LEAD LOCAL FLOOD AUTHORITY, HERTFORDSHIRE  
COUNTY COUNCIL – ADDENDUM TO PROOF OF EVIDENCE  
IN SUPPORT OF ST ALBANDS CITY AND DISTRICT COUNCIL

EVIDENCE OF KATHERINE WATERS (MSC, BSC, C.WEM, MCIWEM), ON  
BEHALF OF HERTFORDSHIRE COUNTY COUNCIL

BRICKET WOOD SPORTS AND COUNTRY CLUB, PAINTBALL  
SITE & BRICKET LODGE, LYE LANE, BRICKET WOOD,  
HERTFORDSHIRE, AL2 3TF

PINS REFERENCE: APP/B1930/W/24/3338501  
PLANNING REF: 5/2022/2443

Figure 2-1: Drainage survey extract

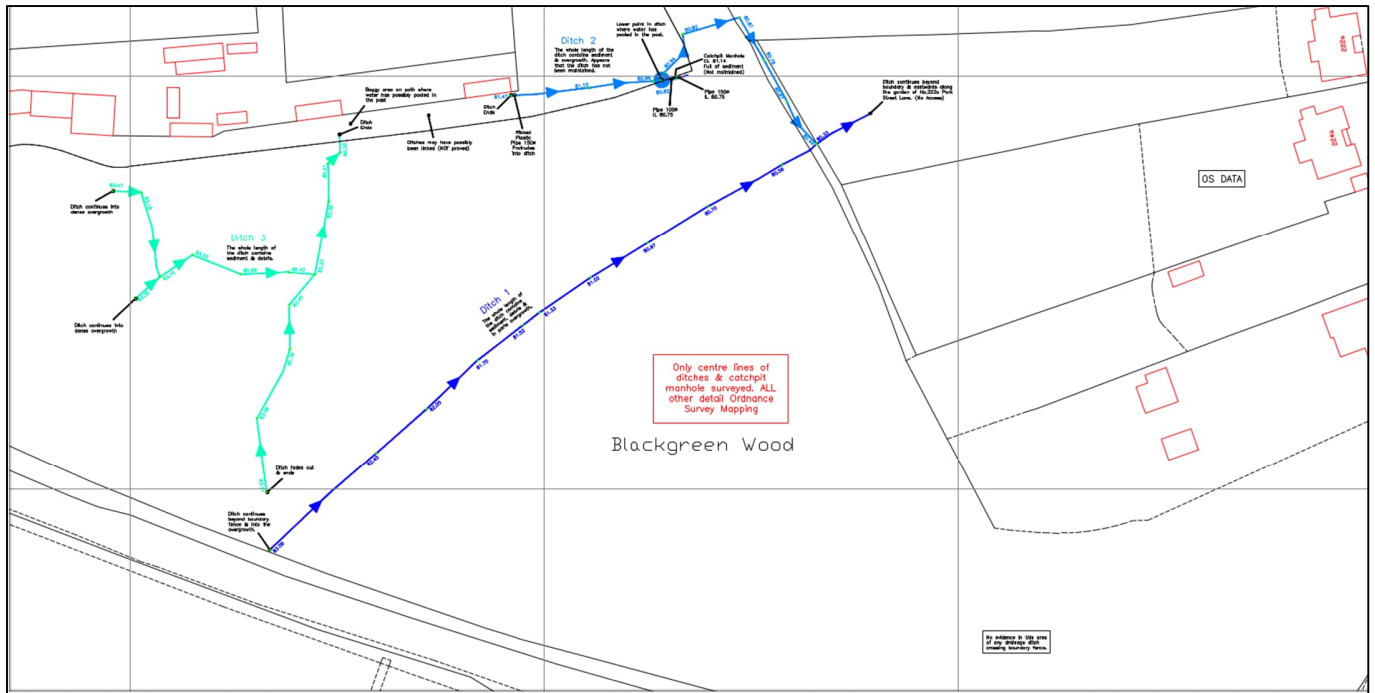
- 2.2.2 The survey potentially picks up three channels. Channel 3, has no inlet or outlet and therefore is more likely to be a manmade depression in the ground.

- 2.2.3 Channel 1 does have an inlet which appears to be from third party land to the south and continues into the grounds of 222a Park Street Lane, however they are unable to verify if the channel still exists beyond this point and the photos are unclear. If any more water was allowed to discharge into this channel without verification to a wider network being established the development will increase flood risk to the properties in the area.

- 2.2.4 Channel 2 appears to have been created to drain some of the hard standing adjacent to it via the 150mm pipe. No survey has been carried out upstream of the pipe, so the area it drains is not known and this can affect the volume and rate of water discharging from it.

- 2.2.5 The survey highlights the low point where water pools and the levels confirm two outfalls, one along a channel that goes north then takes a 90 degree turn to flow south to join with channel 1 and a second outlet via a pipe to the catchpit identified, pipes are constructed in straight lines, so this is likely to have connected directly to channel 2 to the east. It is likely that the first channel was constructed due to the pipe being impacted by tree roots as seems to be shown by photo 3 of the Blackgreen Wood Survey report.

- 2.2.6 The survey includes a note to the south of property 228 Park Street Lane that there is no evidence of any watercourses in this area. This is a key point to note as the appellants own evidence shows there is no watercourse or evidence of a watercourse in this area as proposed by the drainage strategy.

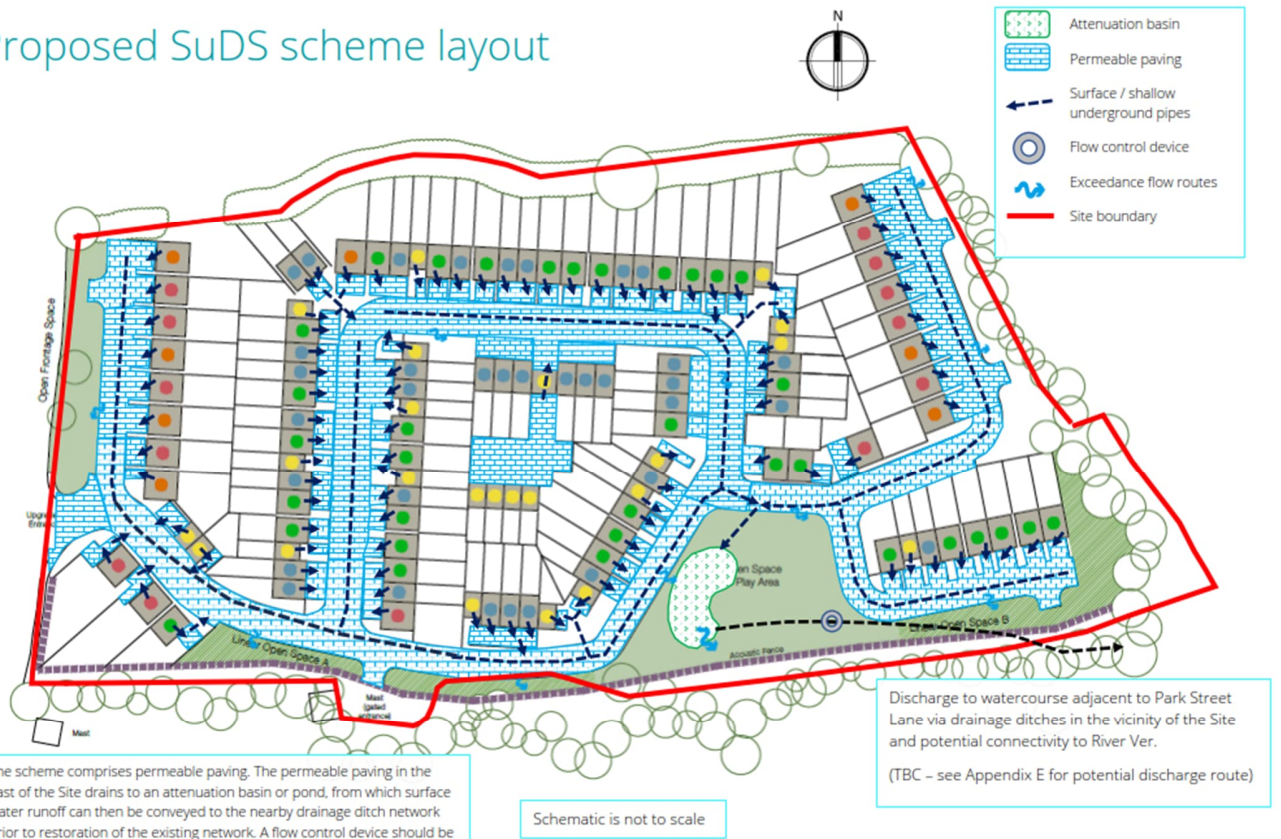
- 2.3.11 The strategy update continues to comment on the ancient woodland, I am unable to provide an opinion on the acceptability of the works to the ancient woodland as this is not my specialist area and in line with my professional code of conduct and ethics it would not be appropriate for me to make assumptions and judgements on an area outside my expertise which could mislead the inspector. I can, however, as highlighted in the above paragraphs, comment on the proposed drainage ditch as it is not a restoration but the creation of a new ditch. It is likely that the ditch within 222a was the original route of the watercourse but has since become blocked and potentially removed in the past, its exact route is unknown. The bypass channel from the area where the catchpit has become blocked due to the impact of tree roots is the new channel which connects to the main channel as identified in the survey (Channel 1).

2.3.12 As highlighted in Paragraph 21, the proposal includes the creation of a watercourse through third party land, which the site has no right to undertake and therefore can be refused by the landowner. An appropriate agreement in principle will be required prior to consent otherwise the site will not be able to drain appropriately and would need to find an alternative discharge point and potentially decrease the discharge rates increasing the volume of attenuation on site impacting the developable area.

Figure 2-3: Extract of Appendix E of Geosmart Report

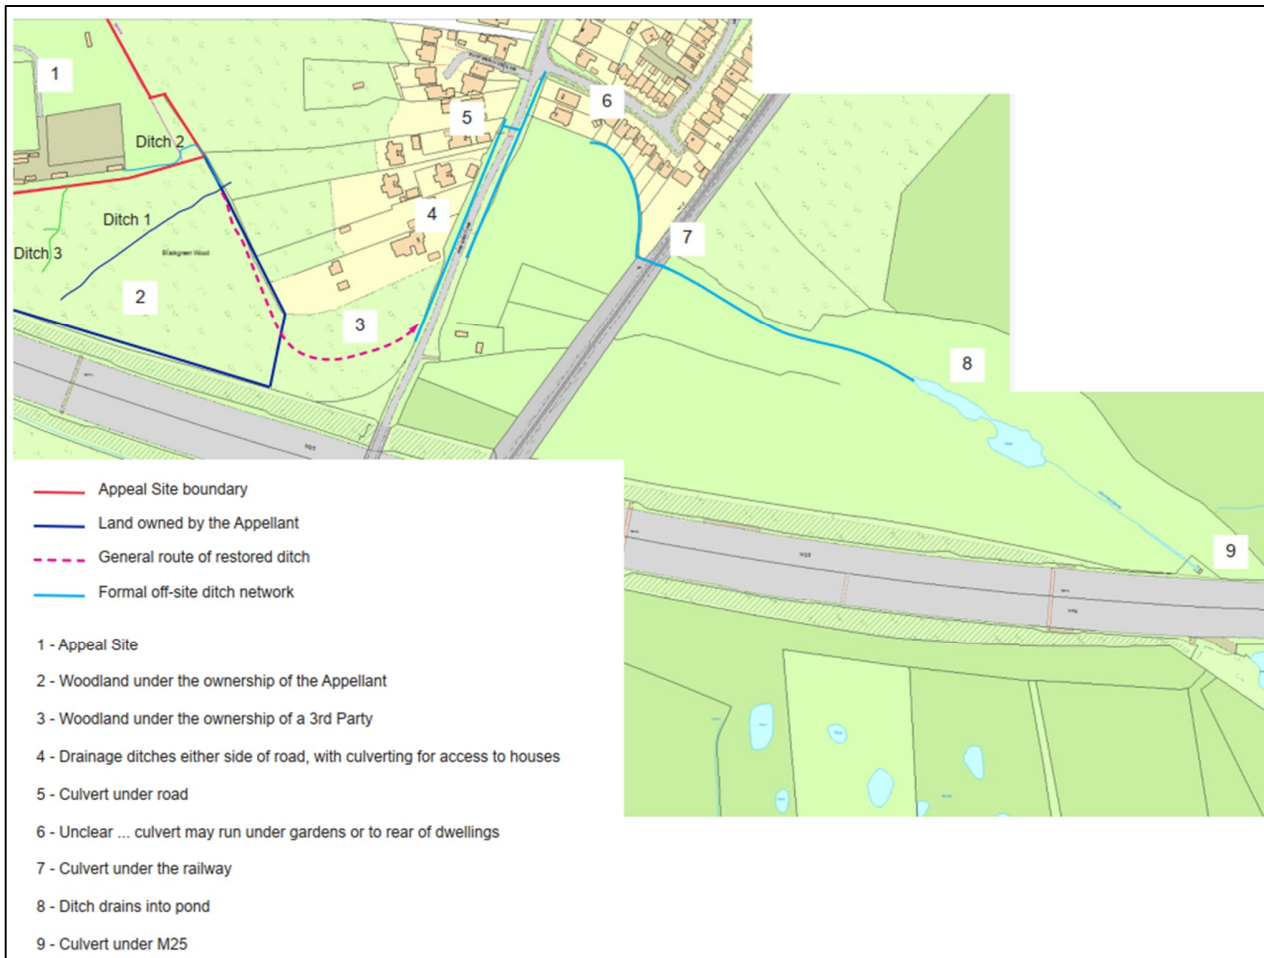
- 2.4.3 A new drainage design has been submitted as part of the revised information. Table 2 states that the design comprises of permeable paving (778.4m<sup>3</sup> of storage), swales (130m<sup>3</sup> of storage), and an attenuation basin (510m<sup>3</sup> of storage) to provide the required 1409.5m<sup>3</sup> with an additional allowance for freeboard. An extract of the accompanying drainage drawing is shown in figure 2.2 below. It should be noted, the swales are not shown on the drawing and without these the system would not provide the attenuation storage required for the 1 in 100 (1%) plus climate change critical storm with an allowable discharge rate of Qbar (1.73 l/s/ha (as per the submitted calculations)).

- 2.4.4 It is still unclear as to why only 1409.5m<sup>3</sup> of storage is required as the calculations in Appendix B show 2102.9m<sup>3</sup> of storage is required. Therefore, we are unable to determine if the appropriate volume of storage has been allowed for within the site proposal and the developable area.
